Date November 15, 2018
To Town of Cumberland Planning Board
From Carla Nixon, Town Planner
Subject **Major Subdivision Amendment: Orchard Road - 10 Lot Subdivision**

The applicant is TZ Properties. The applicant is requesting approval of a subdivision amendment to a previously approved 10 lot clustered subdivision on Orchard Road. The proposed amendment reflects the relocation of the former Lot # 10 to a new location. This amendment does not increase the number of lots, the amount of open space or the roadway layout. The lots will be served by private water and septic systems. The 24.9 acre parcel is located on Orchard Road (approximately 750' south of the intersection with Whitney Road) and is shown on Tax Assessor Map R-08, Lot 59 and on a portion of Map R08, Lot 59B in the Rural Residential 2 (RR 2) zoning district. Will Haskell, P.E. of Gorrill Palmer Engineers is the Applicant's representative.

Drawing No.

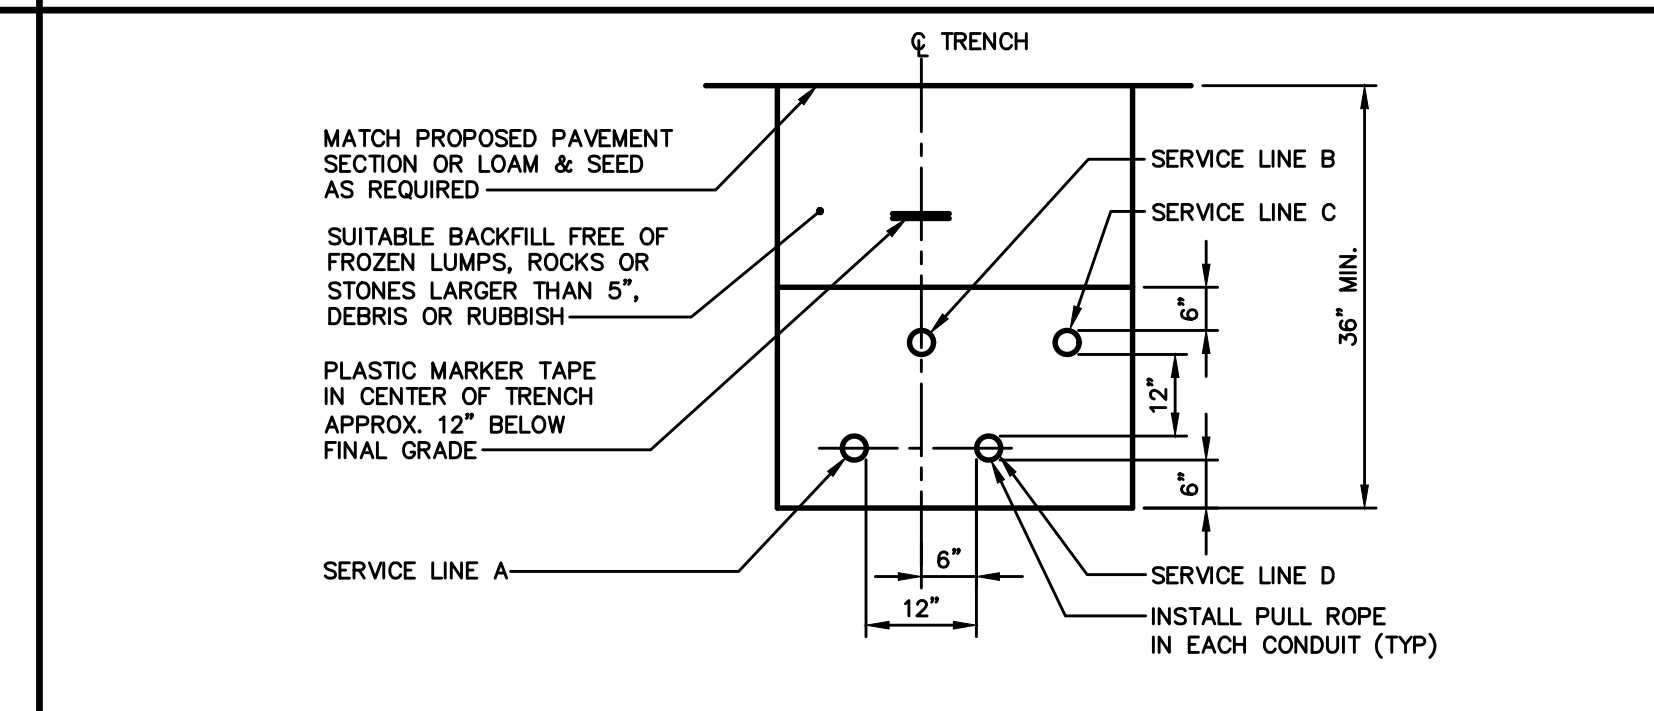
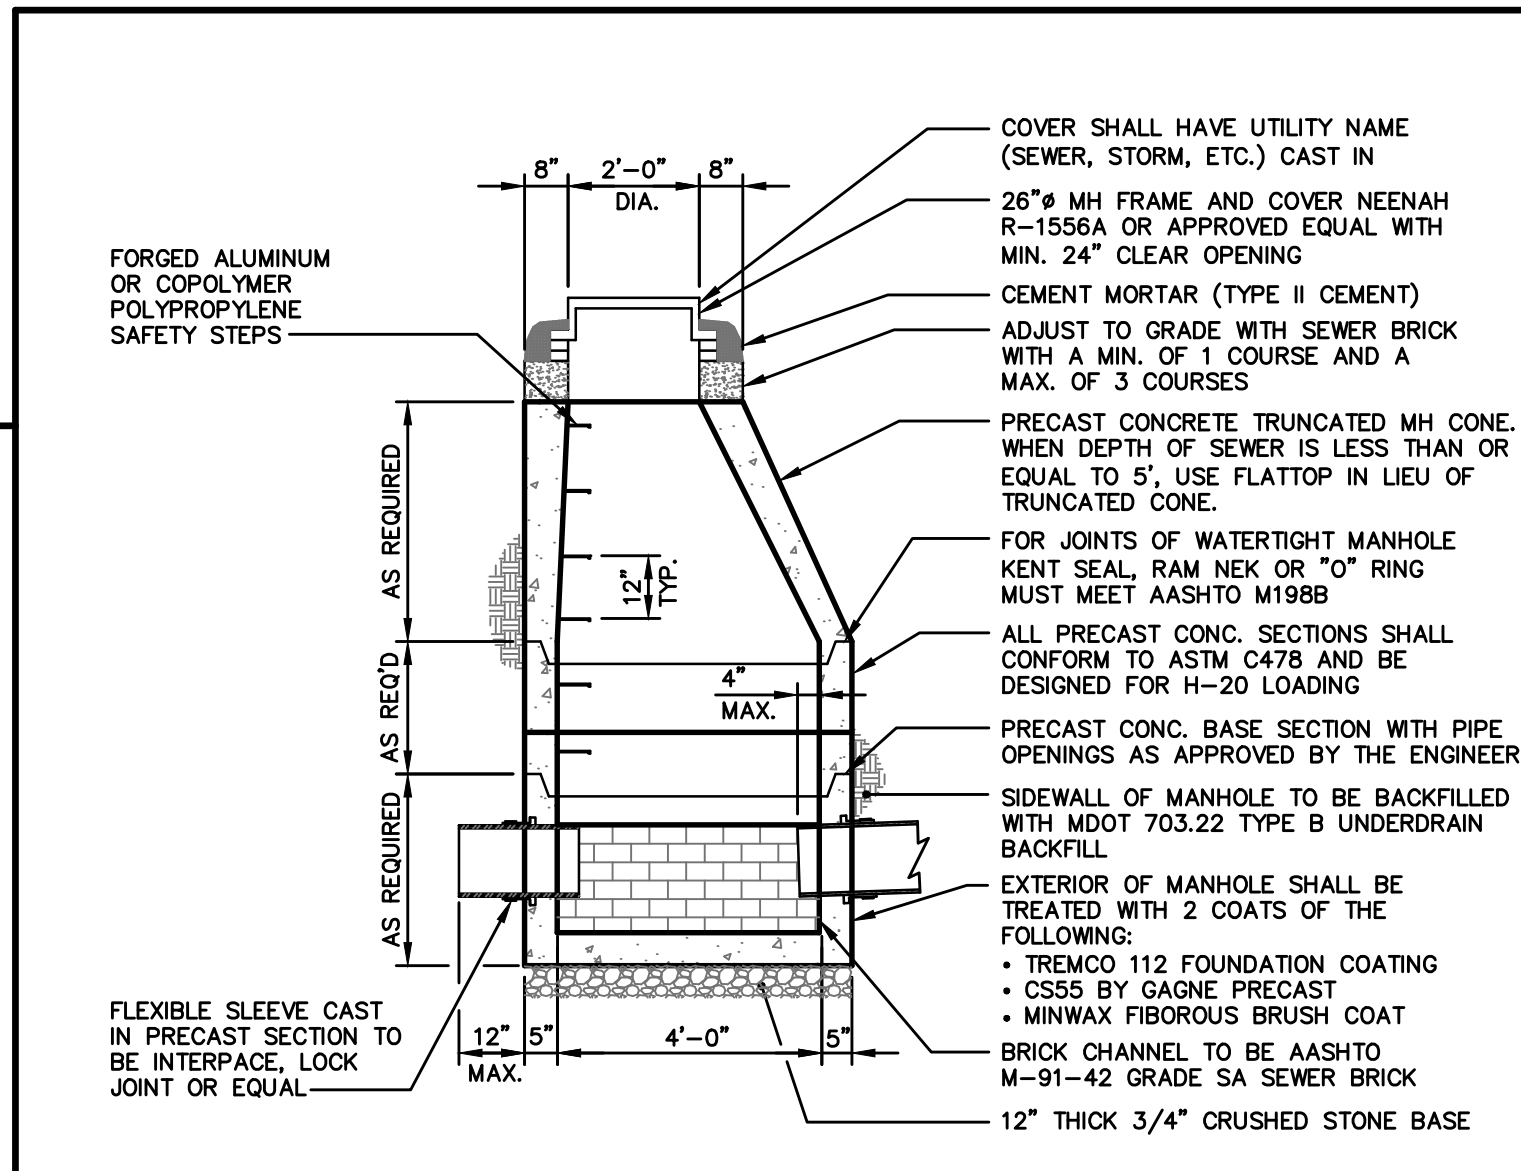
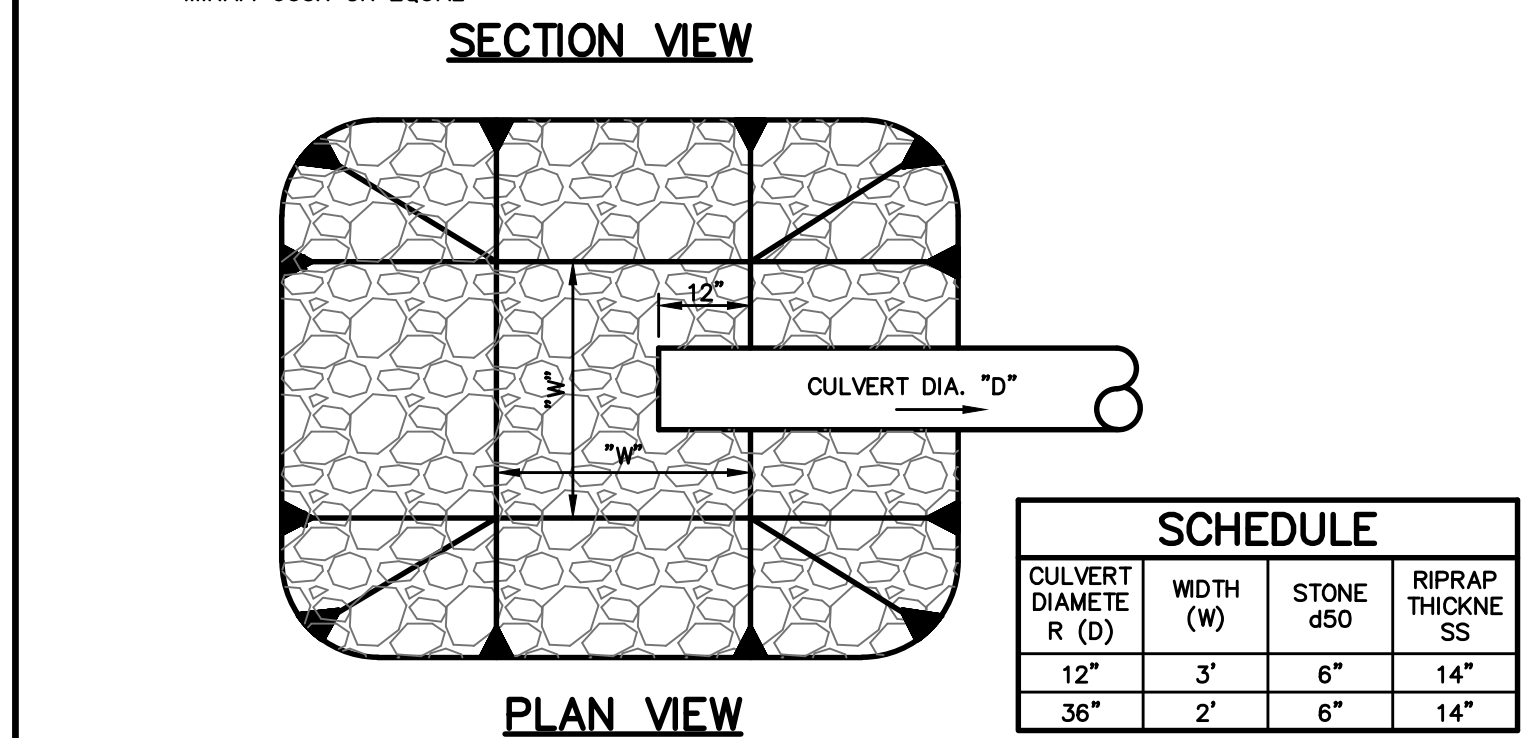
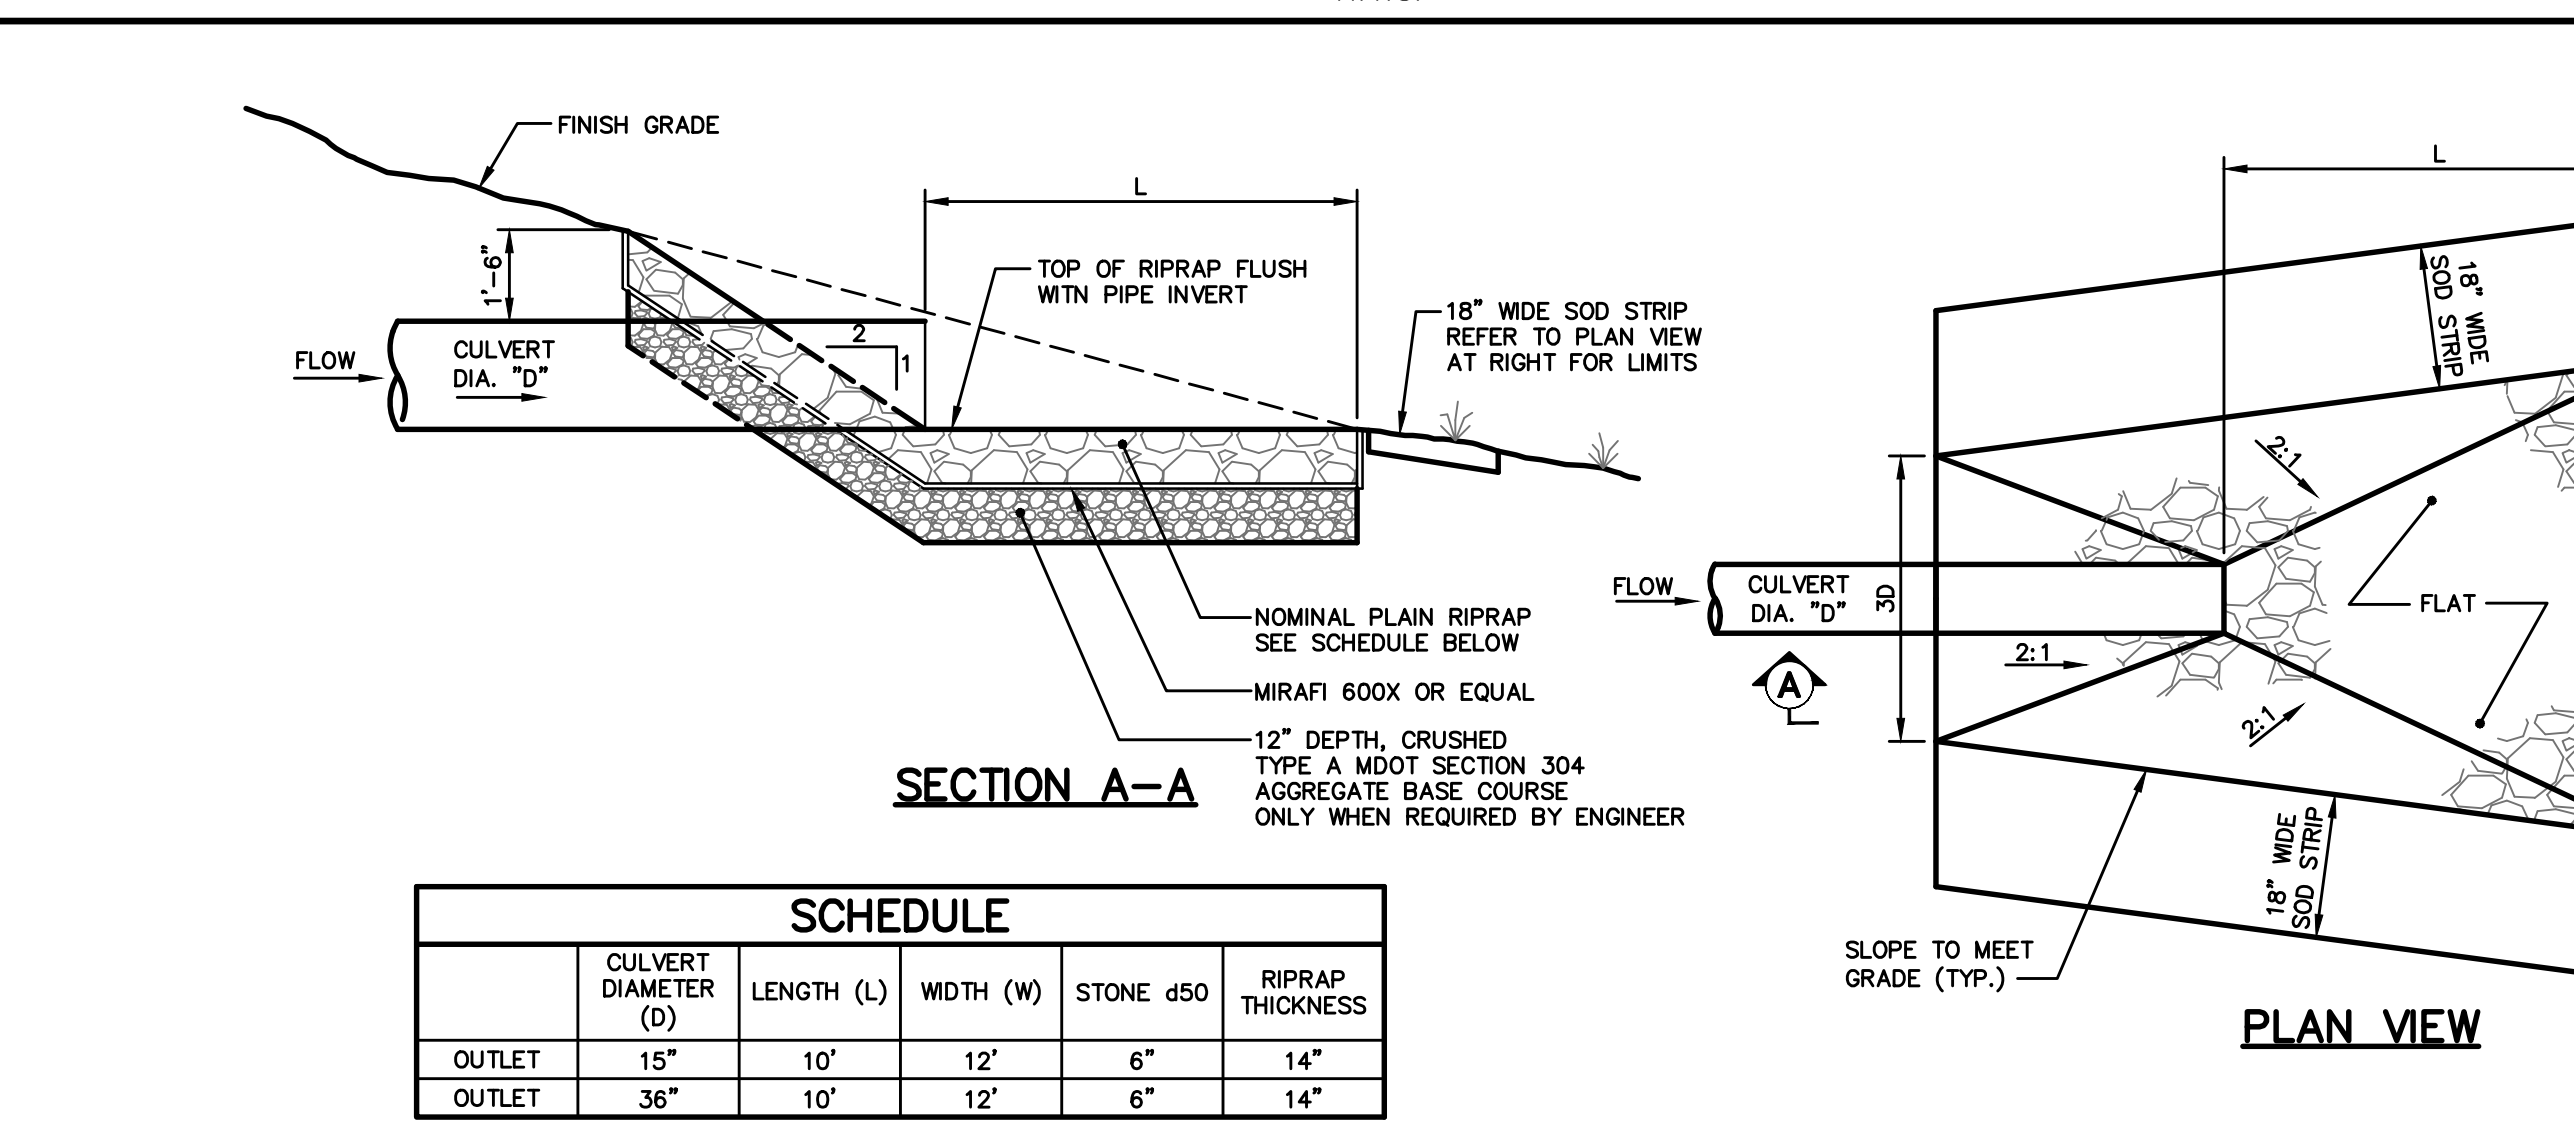
1. The curb locations shown on the road sections on Drawing No. 10 do not appear to match the curb locations shown on Drawing No. 7.

1. The curb locations shown on the road sections on Drawing No. 10 do not appear to match the curb locations shown on Drawing No. 7.
2. Please verify the side setback for lot 10 near the southwest property corner is 30 feet (minimum) from the property line.

Response: Drawing 10 will be revised to reflect the curb locations shown on Drawing 7.
